Vermont Agency of Transportation
RECEIVED
Earth Tone 8.8.8 ©2002 C-Prints-Gold Software Inc. Rev 12.07
CK'D BY J.E.L. OK'D BY J.E.L.
May 15, 2013
RESUBMIT Approved
BY J.E.L. DATE 03.18.2013

Vermont Agency of Transportation
RECEIVED
CK'D BY C.A.M. OK'D BY J.A.G.
Dec. 06, 2012
RESUBMIT APPROVED AS NOTED ✓
BY J. LACROIX DATE 12-18-2012

LOCATION — TH 7 (BRIDGE ST.), 0.10 MI WEST OF RTE. 14
BRIDGE — 11
PROJECT — BRF 6100(7)
PROJECT NAME — BARRE TOWN
—
DESIGNER — VTDOT
CUSTOMER — MILLER CONSTRUCTION

DESCRIPTION: VERSIFLEX ELASTOMERIC BEARING
WASHINGTON CO., VT

PLAN VIEW

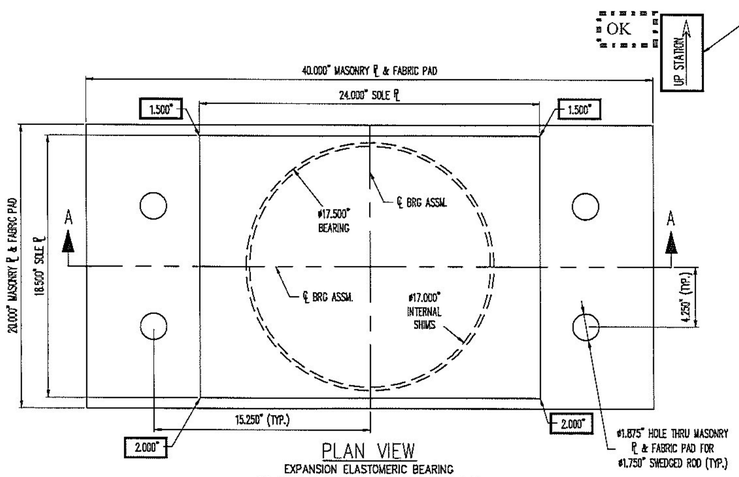
PLEASE VERIFY UP STATION WITH RESPECT TO BEVEL ORIENTATION.

PLEASE VERIFY THAT A COMPOUND BEVEL IS NOT REQUIRED ON THE SOLE PLATE AND PLATE WASHER. IF REQUIRED, CORNER THICKNESS SHALL BE PROVIDED TO D.S. BROWN.

OK

OK

SECTION 'A–A'

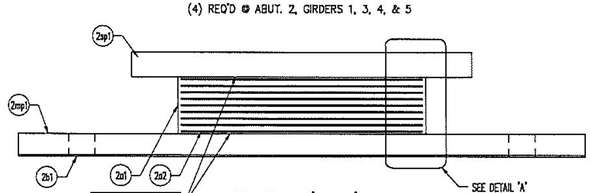
PLEASE VERIFY BEARING IS TO BE BONDED TO THE MASONRY PLATE.

OK

RETAINER DETAIL

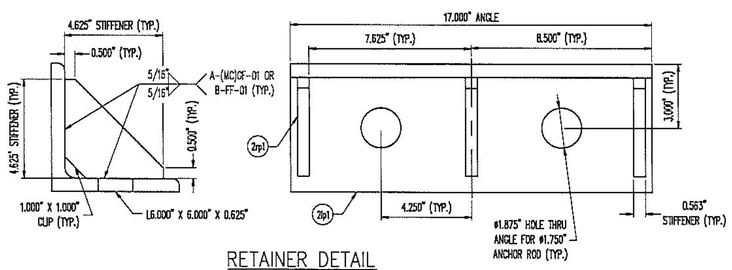
RETAINERS NOT REQUIRED FOR GIRDERS 1,4, AND 5.

DETAIL 'A'

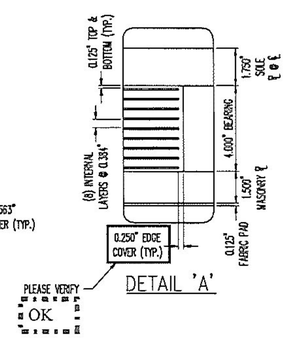
PLEASE VERIFY

OK
